**HIGHLANDS COUNTY BOARD OF COUNTY  
 COMMISSIONERS (HCBCC)  
 PURCHASING DIVISION  
 600 S. Commerce Ave  
 Sebring, FL 33870  
 (863) 402-6500**

DATE: April 3, 2024  
 BID NO. 23-030-KSB                      ADDENDUM No. 4  
 Project.: Highlands County Solid Waste Management Center Class I Cell 5 Landfill  
 Expansion Highlands County Project No. 21078

HIGHLANDS COUNTY SOLID WASTE  
MANAGEMENT CENTER  
CELL 5 LANDFILL EXPANSION  
HIGHLANDS COUNTY, FLORIDA

PROJECT SITE PLAN AND KEY MAP

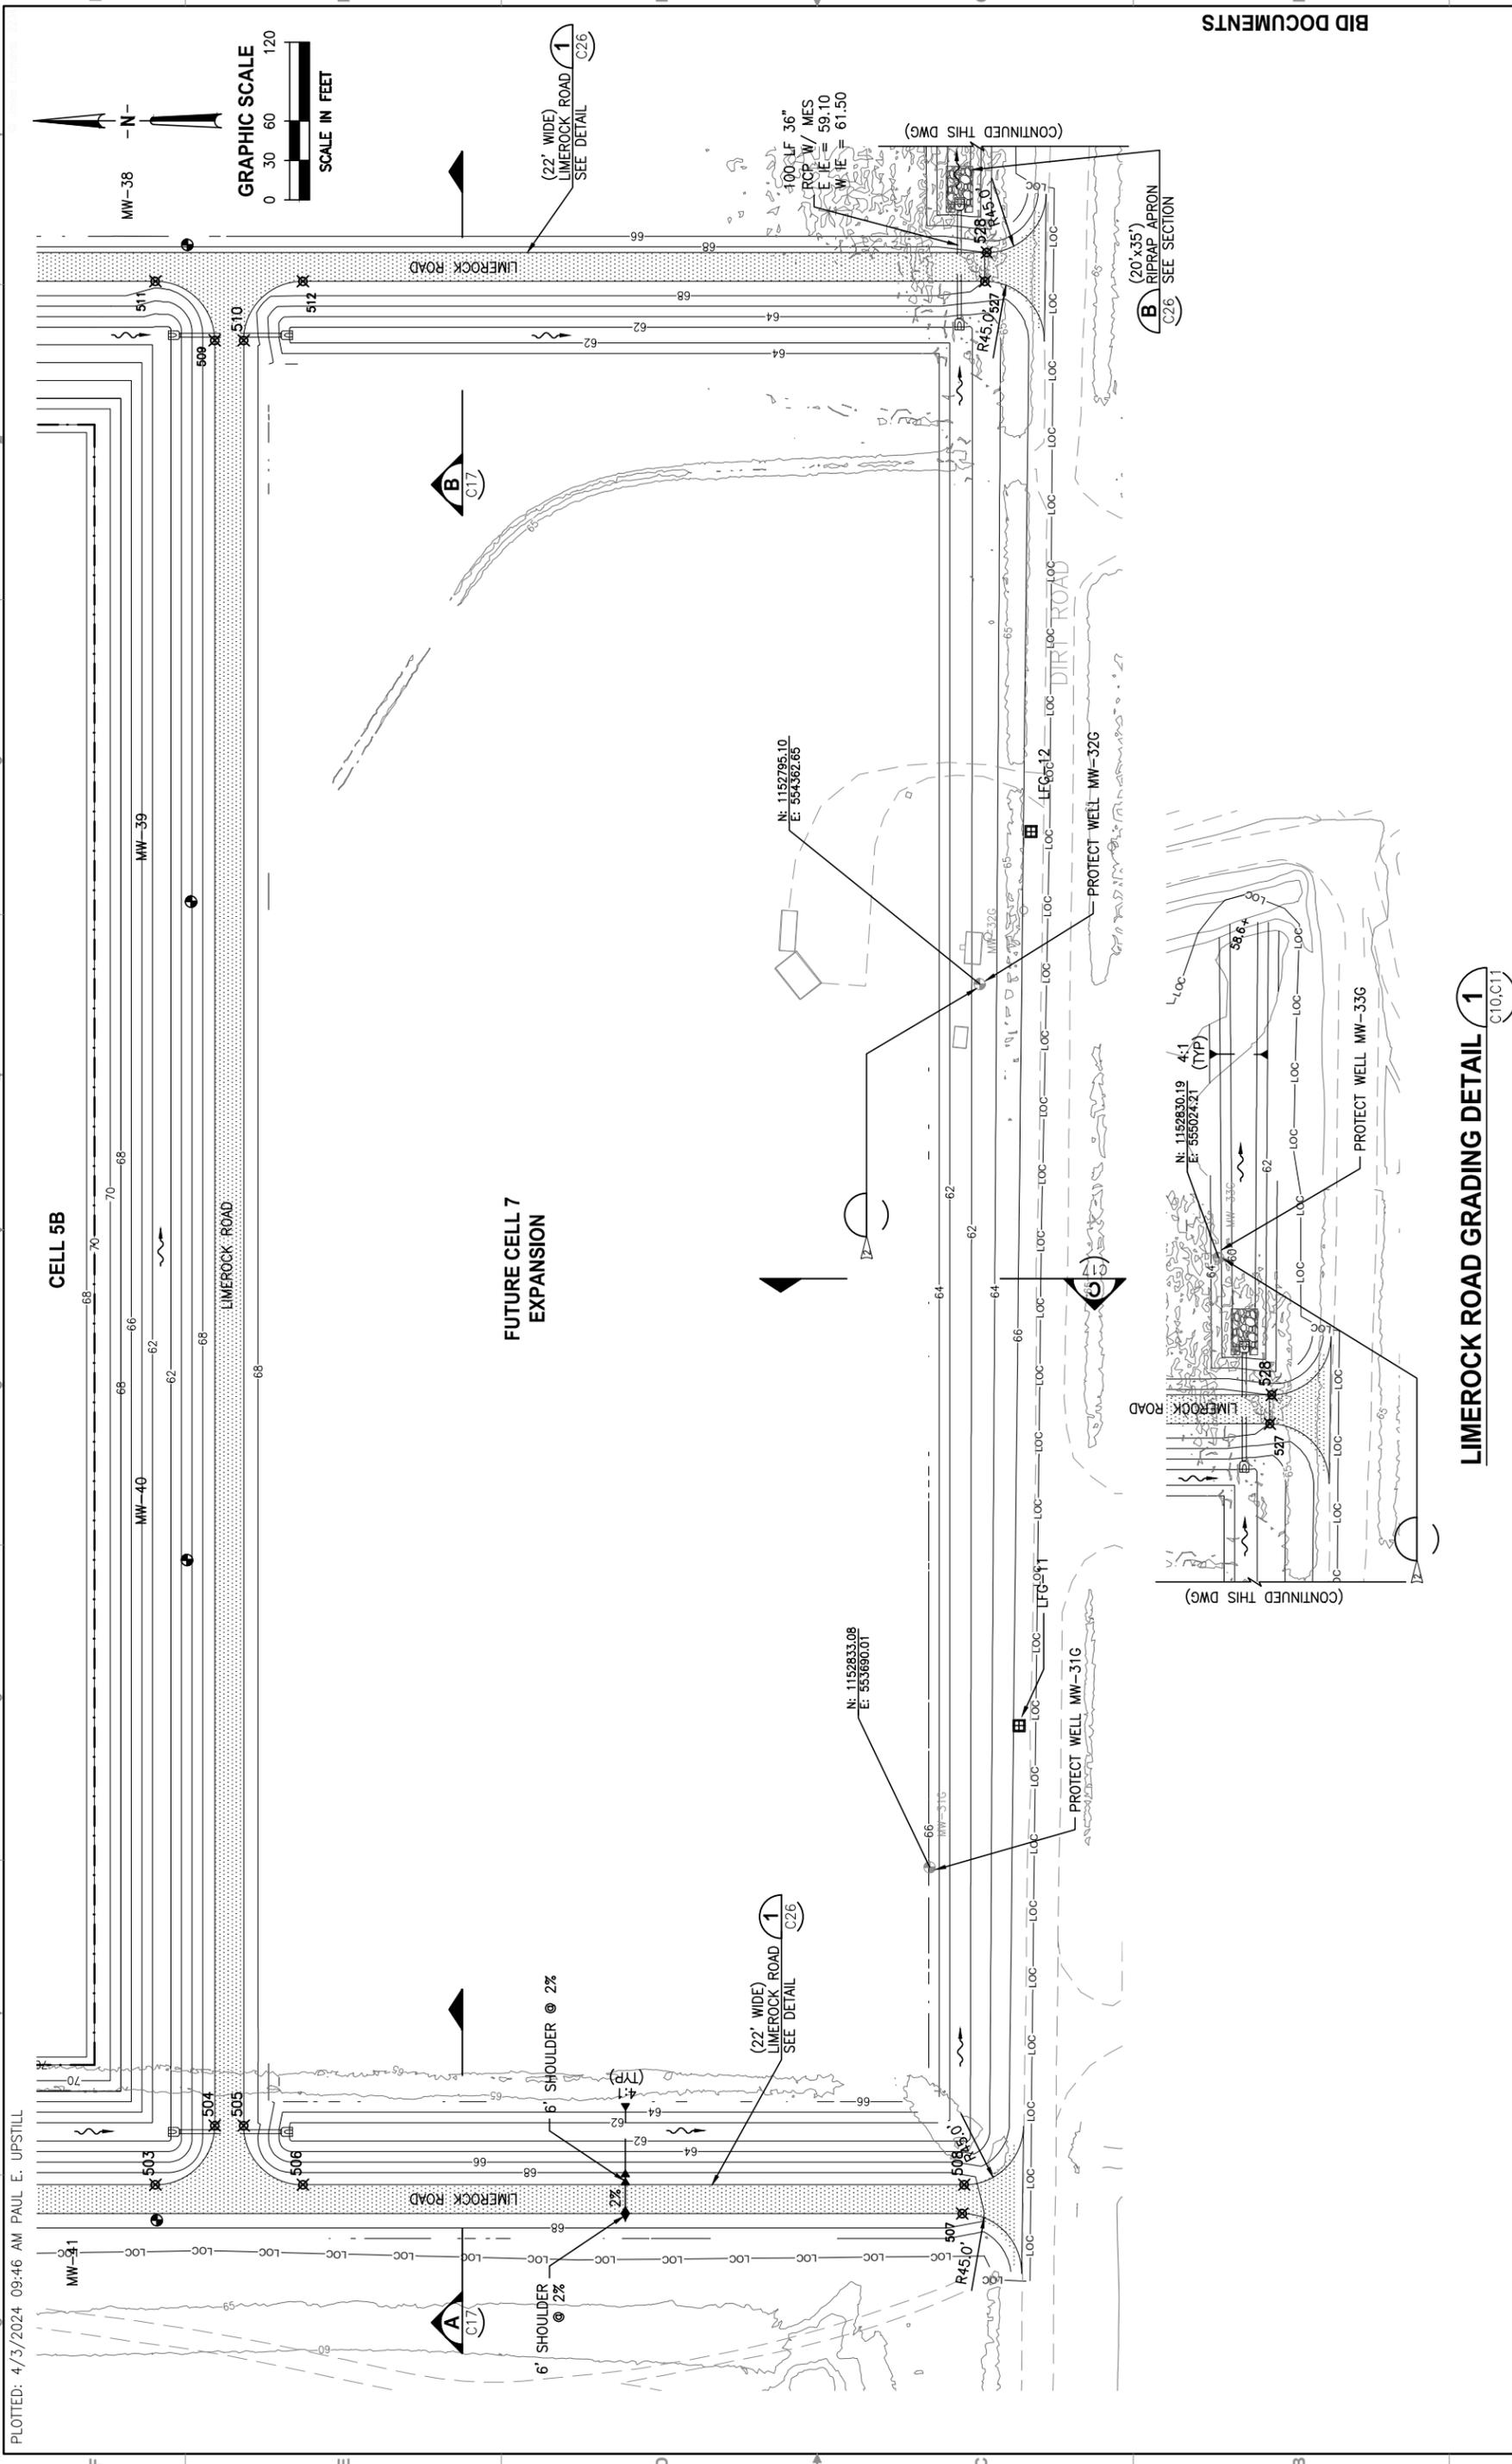
delivering a hard copy of the bid, is it acceptable to package the bid bond with the bid or should it be packaged separately and delivered prior to submission of the bid?
<b>A2</b>	<b>See page 5, Section 00010-1, Invitation to Bid. The bond may be included with the hard-copy submission package.</b>
<b>Q3</b>	The "Statement of Indemnification" form to be submitted with the bid includes the Florida Department of Transportation (FDOT). Will this statement of indemnification apply to FDOT?
<b>A3</b>	<b>Division 0, Section 00160-8, Certificates and Forms, relating to "Florida Department of Transportation (FDOT)" is to be removed from the solicitation package. This is not applicable to this project.</b>
<b>Q4</b>	Where should the Contractor plan to stockpile material stripped from the Cell 5 footprint?
<b>A4</b>	<b>This material shall be stockpiled to the east of the dewatering area. Drawing C2 has been revised to indicate the location of this stockpile. Please note that this material will become the property of the Owner for their use. Additionally, the Owner may elect to strip this material themselves prior to the beginning of work by the Contractor. The Contractor shall install a silt fence around the stockpile meeting the requirements of Drawing EC3. Attachment 1.a provides Revised Drawing C2. Attachment 1.b provides redline markups showing the revisions to the Drawing C2.</b>

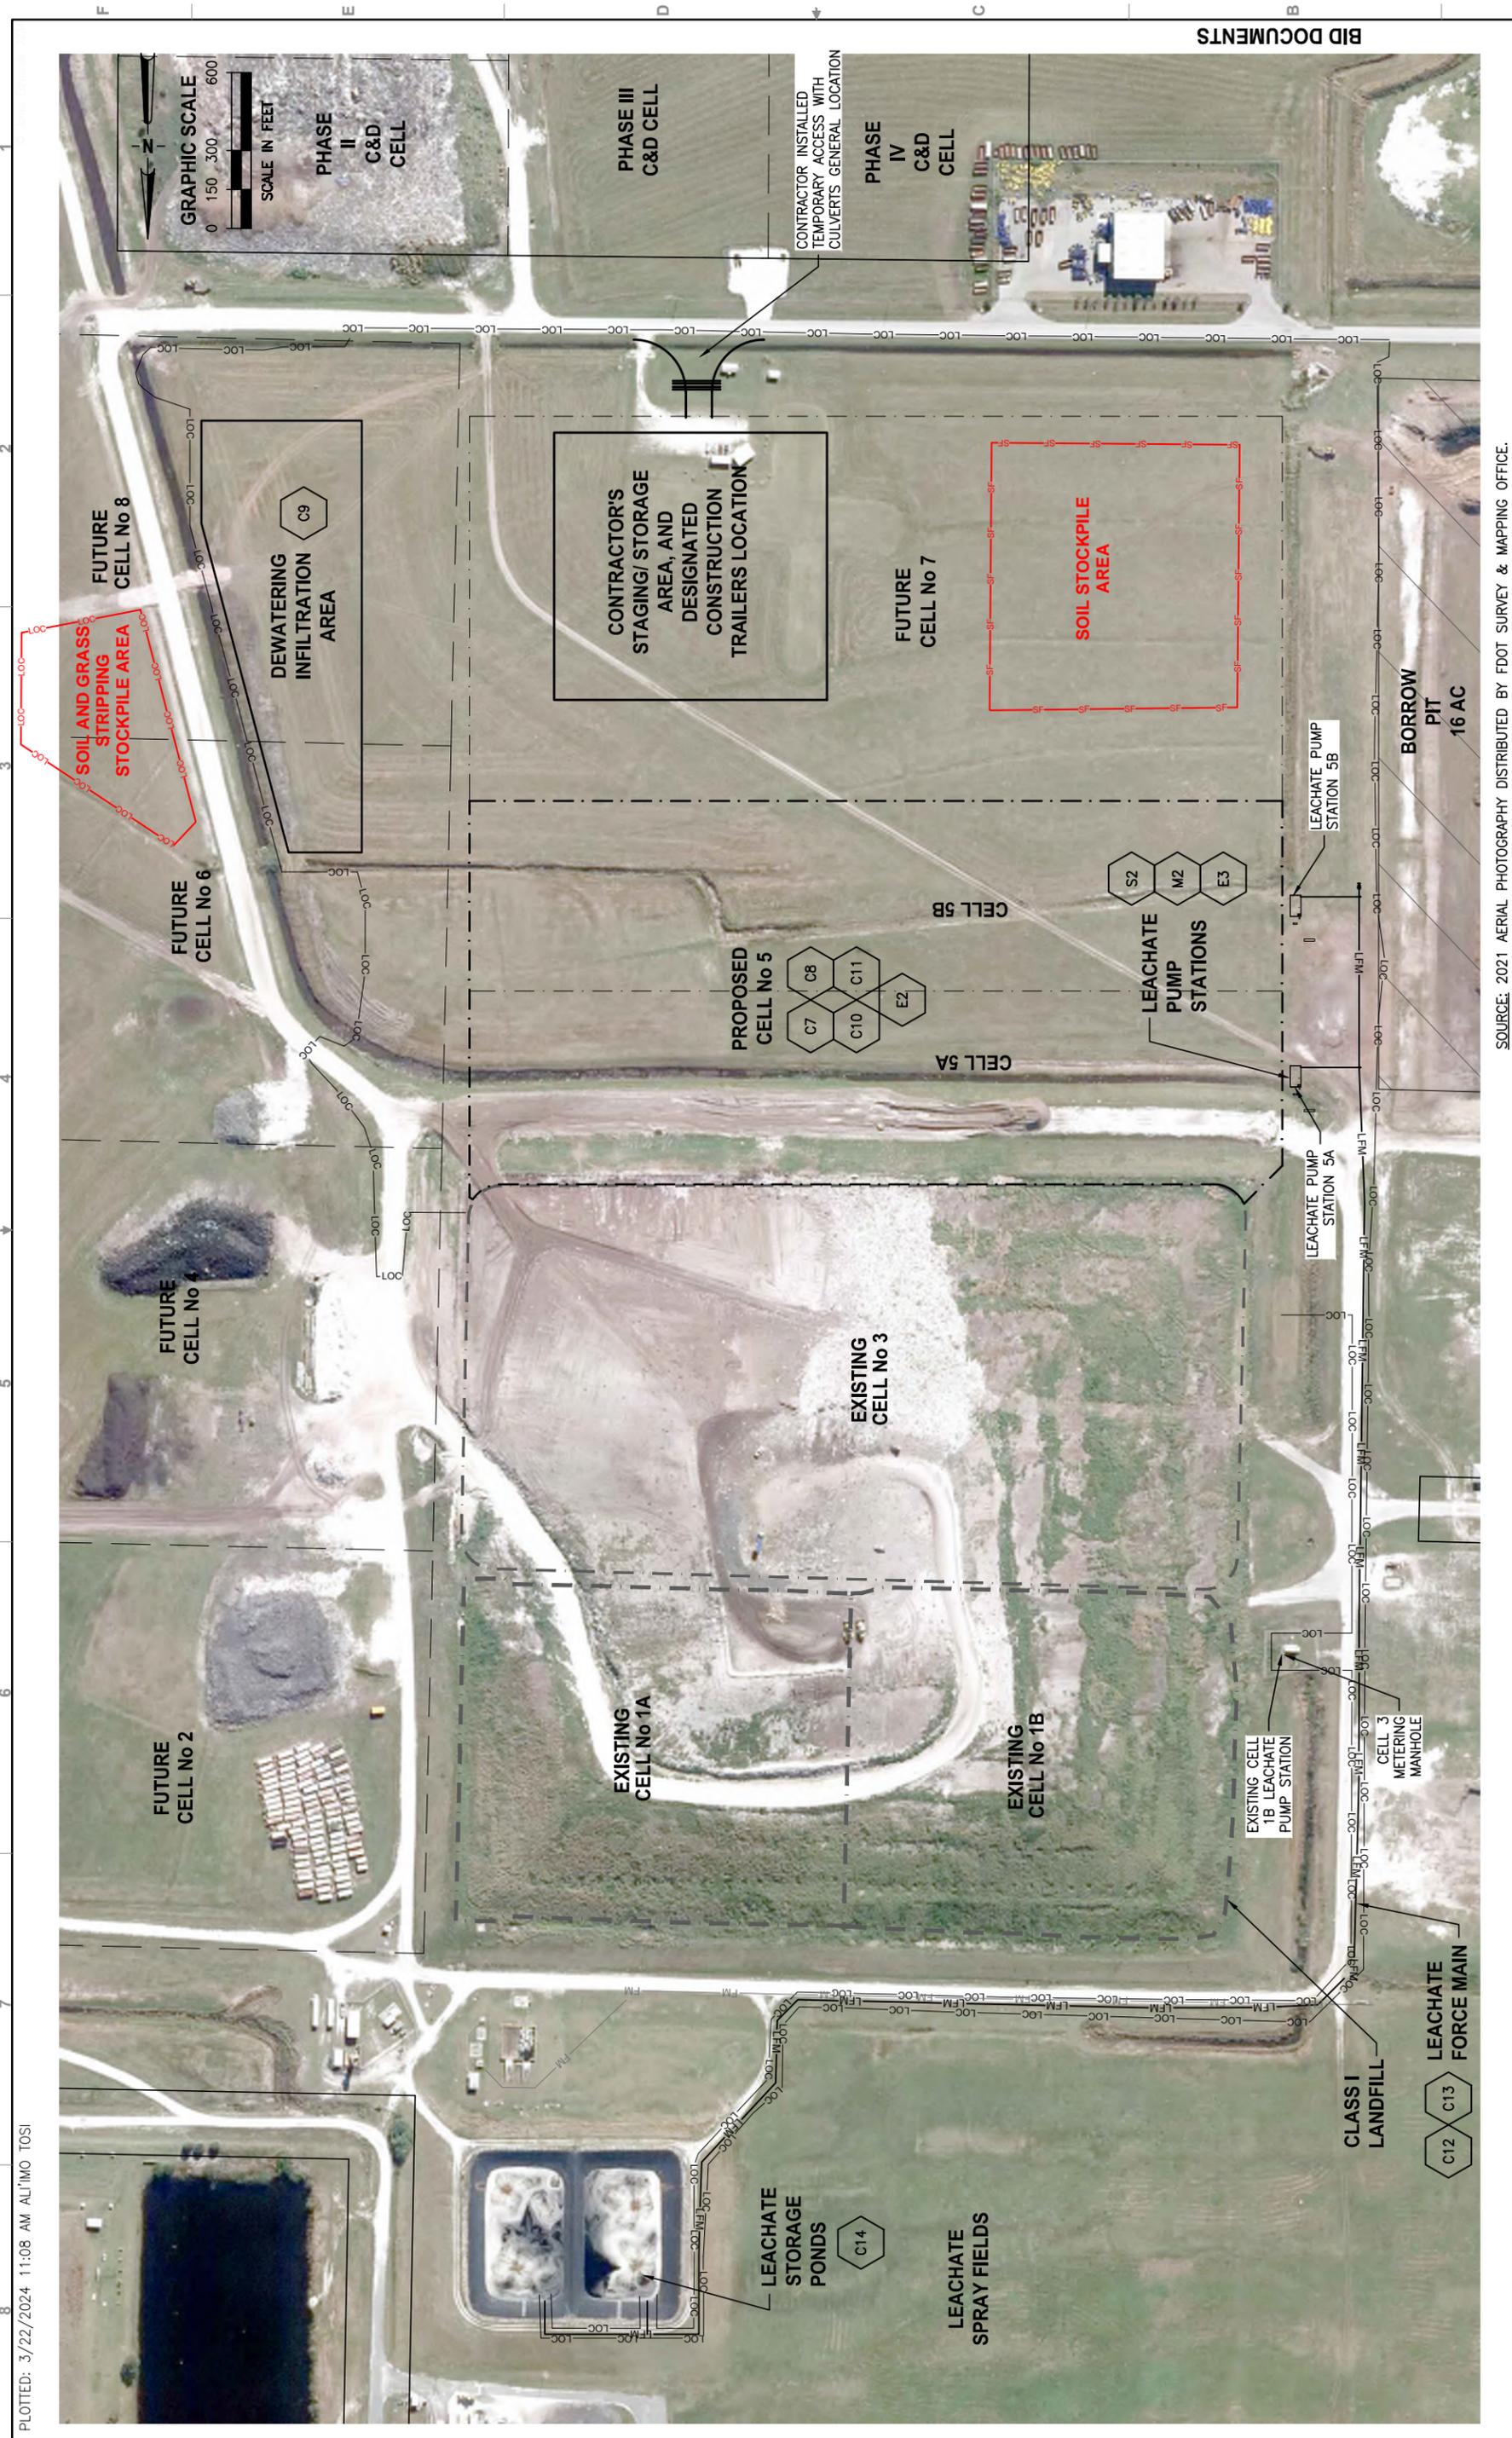
<b>Q23</b>	Detail 1 on Drawing No. C24 instructs us to protect existing groundwater monitoring well MW-31G. Does this existing groundwater monitoring well also get raised, like MW-32G and MW-33G? Or, is it to be left alone and not raised.
<b>A23</b>	<b>Raising the groundwater monitoring wells has been removed from the project. Please refer to the response to Question 22 for additional details.</b>
<b>Q24</b>	Note 1 on Drawing No. C8 instructs Contractor to install piezometers within the Cell 5 project area to monitor groundwater levels and dewatering system performance. However, there are no details of new piezometers to be installed. Please provide the quantity of piezometers to be installed, as well as the details and specifications for the work.
<b>A24</b>	<b>The piezometers shall be of the same general design as the groundwater monitoring wells shown on Drawing C27 but with only the PVC pipe stub up above grade and not the other above-grade components including concrete pad, aluminum case, and bollards. The piezometers shall be screened in the zone in which groundwater is to be observed. Additional information on installation is included in Specification Section 02526, Groundwater Monitoring Well Construction and Well Abandonment. Please refer to the response to Question 7 for additional details.</b>
